URGENT FIELD SAFETY NOTICE
fabian HFO and fabian +nCPAP evolution Volume Guarantee function
for Field Safety Corrective Action FSCA-20-001

FSN Ref: FSCA-20-001-FSN

FSCA-20-001
 User Work Instruction
Volume Guarantee function
fabian HFO and fabian +nCPAP evolution

Funktion „Volumengarantie“ (VG) nicht verwenden

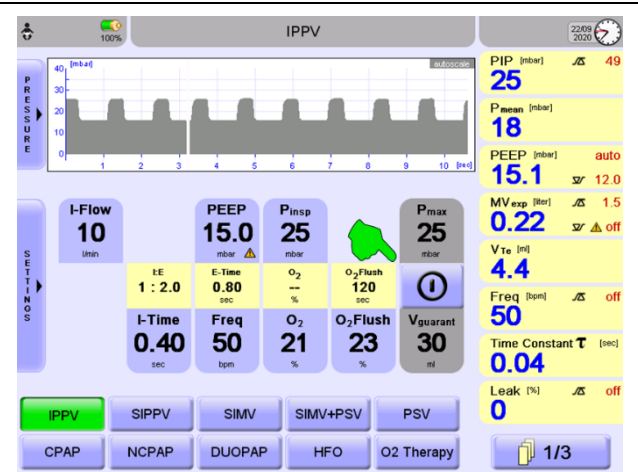
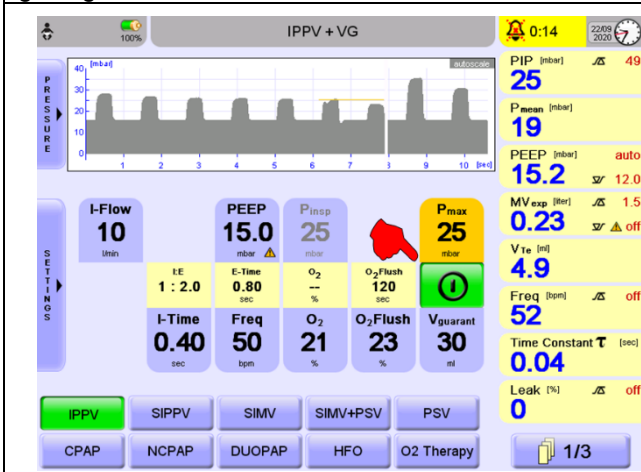
Beenden Sie die Verwendung der optionalen Funktion „Volumengarantie“ mit einem betroffenen Beatmungsgerät fabian HFO und +nCPAP evolution und/oder aktivieren und verwenden Sie diese Funktion nicht, bis das Software-Update installiert wurde, das die Fehlfunktion der Volumengarantie behebt.

fabian +nCPAP evolution: Funktion „Volumengarantie“ (VG) abschalten

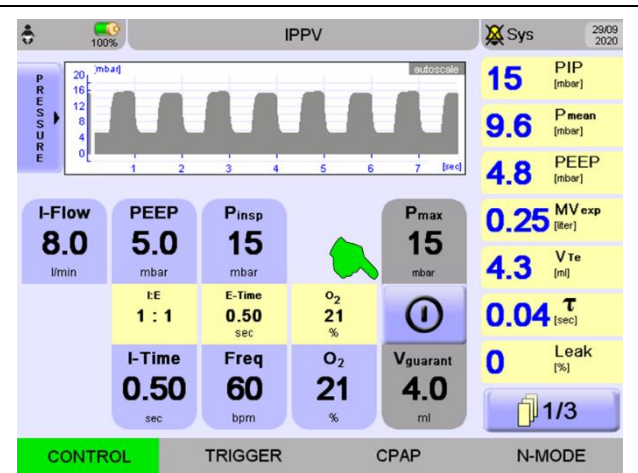
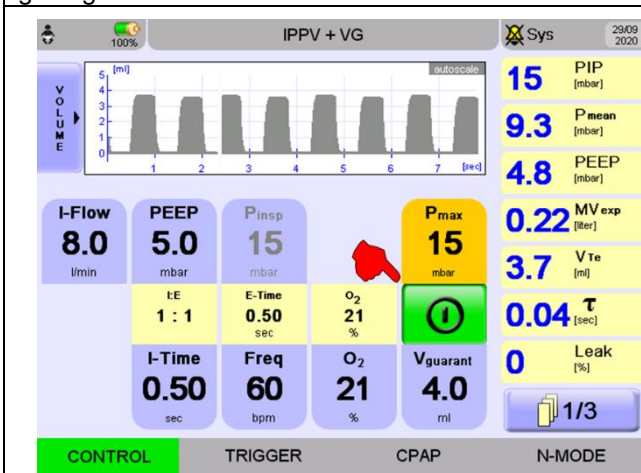
Wenn die in der unten stehenden Abbildung gezeigte Schaltfläche grün ist, ist die VG-Funktion aktiviert. Bitte deaktivieren Sie die Funktion, indem Sie auf die gezeigte Schaltfläche drücken.

Wenn die in der unten stehenden Abbildung gezeigte Schaltfläche nicht grün ist, ist die VG-Funktion deaktiviert. Aktivieren Sie die Funktion nicht.

Do not use the Volume Guarantee (VG) function

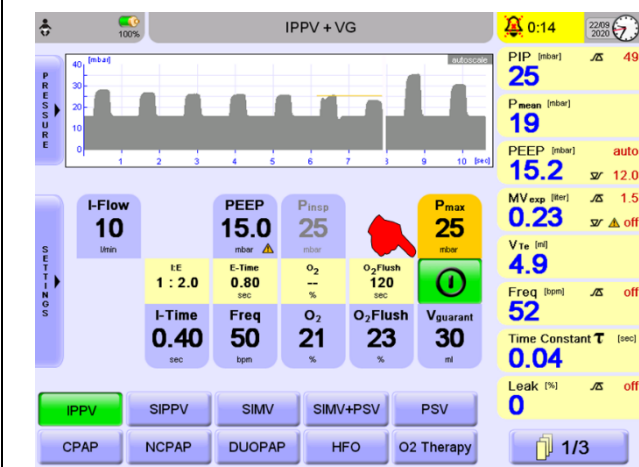
Discontinue use of, and / or do not activate and use the optional Volume Guarantee function with the affected fabian HFO and +nCPAP evolution devices, until the Software update addressing the Volume Guarantee malfunction is installed.

fabian HFO: switch off Volume Guarantee (VG) function

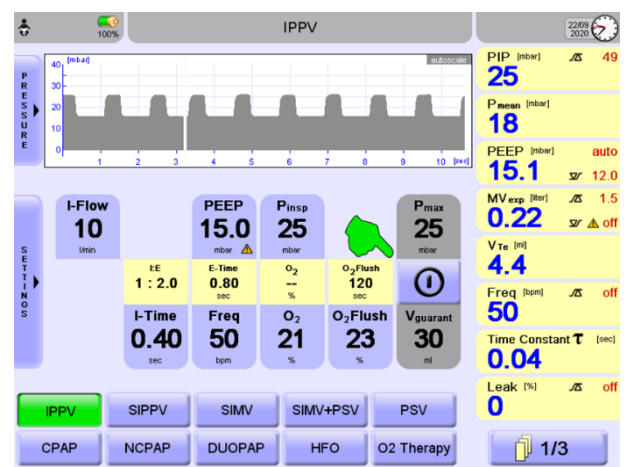
When the softkey indicated below is green, the VG function is activated. Please deactivate it by pushing the indicated softkey below.

If the indicated softkey below is not green, the VG function is deactivated. Do not activate.

fabian +nCPAP evolution: switch off Volume Guarantee (VG) function

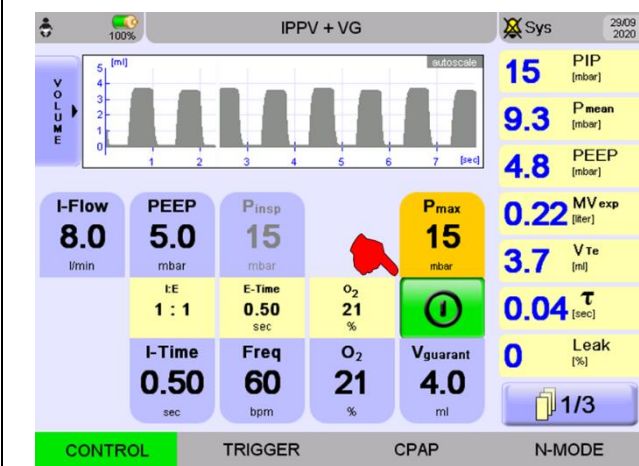
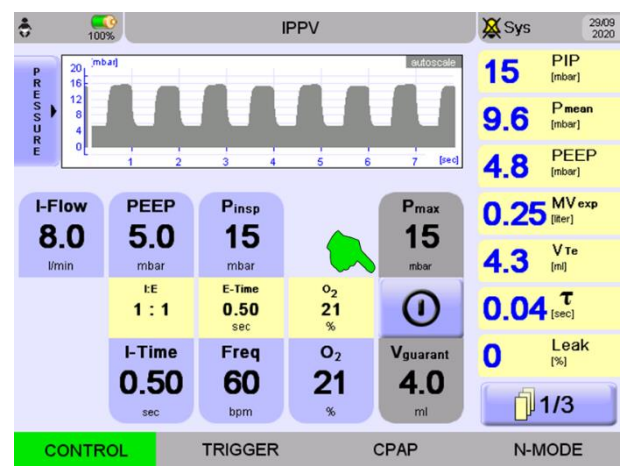
When the softkey indicated below is green, the VG function is activated. Please deactivate it by pushing the indicated softkey.

If this button is not green, the VG function is deactivated. Do not activate.
